Amdt. dated May 1, 2006

Reply to Office action of January 31, 2006

**Amendments to the Drawings**

**REMARKS/ARGUMENTS**

FIG. 1

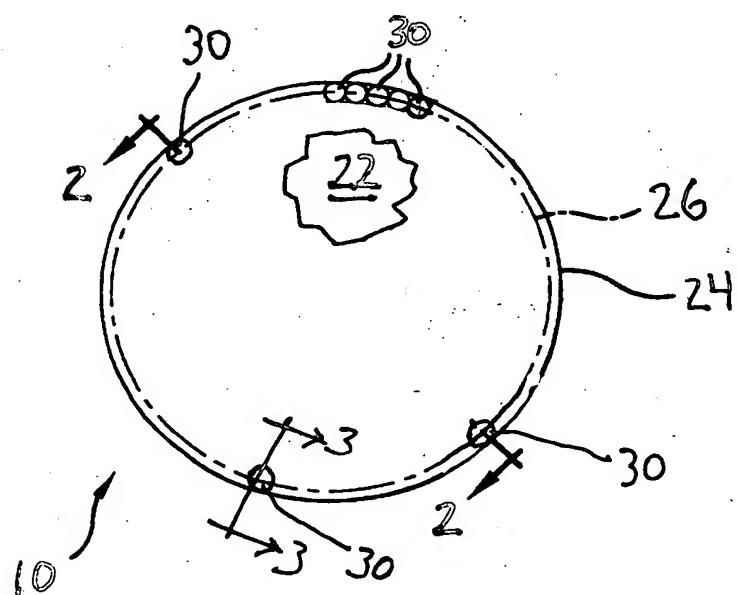
The drawings have been objected to under 37 CFR 1.84(i). Lines, numbers and letters are not uniformly thick and well defined, clean and durable and black (poor line quality) Figures 1-6. The Examiner has requested corrected drawing sheets in compliance with 37 1.121(d).

In response to the Examiner's requirement, submitted herewith for the Examiner's approval are replacement drawing sheets showing Figures 1-6. The drawings on the replacement drawing sheets correspond in subject matter and content to the original drawings filed with this case. No new matter has been added by the replacement drawing sheets.
